UNITED STATES PATENT AND TRADEMARK OFFICE

Office Action Summary	Application No. 10/531,104	Applicant(s) LAIHO, KIMMO	
	Examiner Khanh Dang	Art Unit 2111

DETAILED ACTION

Figure 3

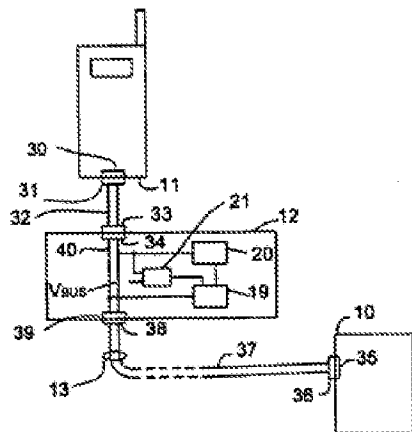
As shown in Applicants' Fig. 3, element 12 is the so-called "device operable as a host device," element 34 is the "first USB port," element 39 is the "second USB port," element 19 is the "host module," element 21 is a "comparator," and element 10 is the so-called "host externally connected to the bus" (note that all USB ports/connectors

including Applicants' USB ports 34 and 39 include Vbus, GND, D+, and D-). The Vbus line of the USB bus is connected to "comparator" 21 while the rest of USB bus lines are connected to the "host module" 19. As shown in Fig. 3 of Oguma, which is reproduced below for ease of reference and comparison, Oguma discloses the so-called "device operable as a host" including a USB bus comprising Vbus, GND, D+, and D-. The device further comprises a first upstream USB port or "first port" having Vbus, GND, D+ and D-, connected directly to the USB bus; and a second USB downstream port or "second port" having Vbus, GND, D+ and D-, connected directly to the downstream of the same USB bus running from the first upstream USB port to the second downstream USB port. The device as shown in Fig. 3 of Oguma also shows the so-called "host module" or bus manager circuit 62 connected directly to the same USB bus; and the "comparator" or voltage circuit 64 detecting coupled to the same USB bus to detect the presence of a host externally connected to the USB bus. A voltage detecting circuit basically comprises a voltage comparator for comprising a supply voltage with a reference voltage (VREF) to detect a change in voltage or a difference between supply voltage and reference voltage. Further, as noted above, a USB bus comprises Vbus, GND, D+, and D-. It is also important to note that Applicants' Fig. 3 shows a Vbus line, and other lines are grouped together as line 40. See at least column 2, lines 39-57, column 4, line 65 to column 6, line 17).

Fig. 3

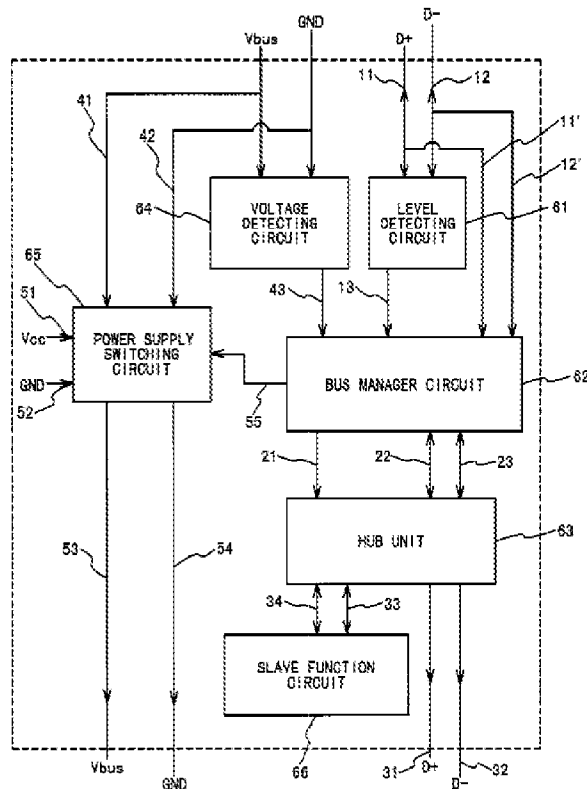
Further, as shown in Fig. 3 of Oguma above, the Vbus and GND of the upstream USB port are connected directly to the corresponding Vbus and GND of the downstream USB port. Element 65 in Fig. 3 of Oguma is simply a power supply switching circuit to supply direct power from different USB power sources. To receive power directly from the Vbus and GND of the upstream USB port, the Vbus and GND of the downstream USB port must be connected directly to the Vbus and GND of the upstream USB port. In addition, as shown in Fig. 3, the D+ and D- of the upstream USB port is connected the D+ and D- of the downstream USB port via the bus manager circuit 62 and USB Hub 63. However, in column 4, lines 18-22, Oguma also discloses that the "bus manager circuit 62 passes through the signal [D+ and D-] between host

Thus, the difference between the claim subject matter and that of Oguma is the direct connection between the D+ and D- lines of the upstream USB port and the D+ and D- of the downstream USB port. As shown in Fig. 3 of Oguma, the D+ and D- lines of the upstream USB port and the D+ and D- of the downstream USB port are connected via a USB Hub 63.

Contrary to Applicants’ argument, as already discussed above, the difference between the claim subject matter and that of Oguma is the direct connection between the D+ and D- lines of the upstream USB port and the D+ and D- of the downstream USB port. As shown in Fig. 3 of Oguma, the D+ and D- lines of the upstream USB port and the D+ and D- of the downstream USB port are connected via a USB Hub 63.

optional. When the USB Hub 63 is not employed in Fig. 3 of Oguma, it is clear that the D+ and D- lines of the upstream USB port and the D+ and D- lines of the downstream USB port are directly connected; and as a result, the USB bus passes USB D+ and D- directly from the upstream USB port or “first port” to the USB D+ and D- of the USB downstream port or “second port” responsive to relinquishment of host status.

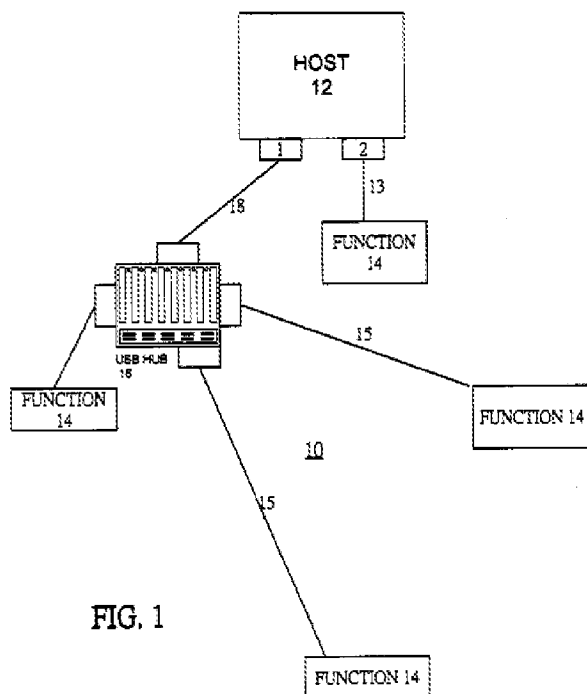
Hsu, in Fig. 1, which is reproduced below for ease of reference and convenience, discloses a plug-and play USB Hub 16 comprising an upstream USB port connected to a host 12 and downstream ports connected to USB devices 14. The purpose of using the USB Hub is to provide additional USB connections/ports to downstream of the USB Hub. See column 1, lines 7-61.

Since the purpose of using a USB Hub is simply expanding the number of downstream USB ports that the USB Host can communicate with, as taught by Hsu, the use of the USB Hub is clearly optional.

Thus, it would have been obvious to one of ordinary skill in the art at the time the invention was made not to use the USB Hub in Oguma, since the purpose of using a USB Hub is simply expanding the number of downstream USB ports that the USB Host can communicate with, as taught by Hsu, and thus, the use of the USB Hub is clearly optional. When the USB Hub 63 is not employed in Fig. 3 of Oguma, it is clear that the D+ and D- lines of the upstream USB port and the D+ and D- lines of the downstream USB port are directly connected; and as a result, the USB bus passes USB D+ and D- directly from the upstream USB port or “first port” to the USB D+ and D- of the USB downstream port or “second port” responsive to relinquishment of host status.

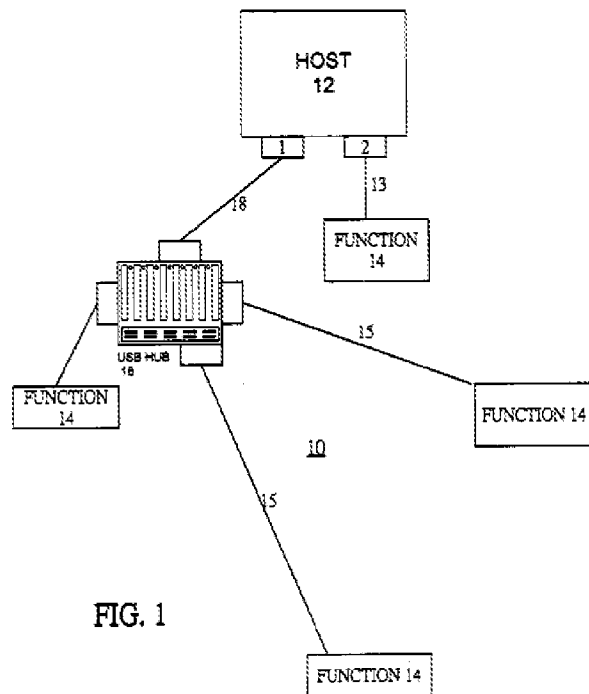
Hsu, in Fig. 1, which is reproduced below for ease of reference and convenience, discloses a plug-and play USB Hub 16 comprising an upstream USB port connected to a host 12 and downstream ports connected to USB devices 14. The purpose of using the USB Hub is to simply provide additional USB connections/ports to downstream of the USB Hub. See column 1, lines 7-61.

Since the purpose of using a USB Hub is simply expanding the number of downstream USB ports that the USB Host can communicate with, as taught by Hsu, the use of the USB Hub is clearly optional.

Thus, it is clear that in the 103 Rejection, it is not suggested by the Examiner that the hub disclosed by Hsu replaces the hub disclosed by Oguma. Instead, it is the Examiner's position that since Hsu discloses that the purpose of using Hub 16 in Fig. 1 above is to simply provide additional USB downstream connections or ports, it is clear that the use of a USB Hub is clearly optional. Thus, as stated above, it would have been obvious to one of ordinary skill in the art at the time the invention was made not to use or eliminate the USB Hub 63 in Oguma, since the purpose of using a USB Hub is simply expanding the number of downstream USB ports that the USB Host can communicate with, as taught by Hsu, and thus, the use of the USB Hub is clearly
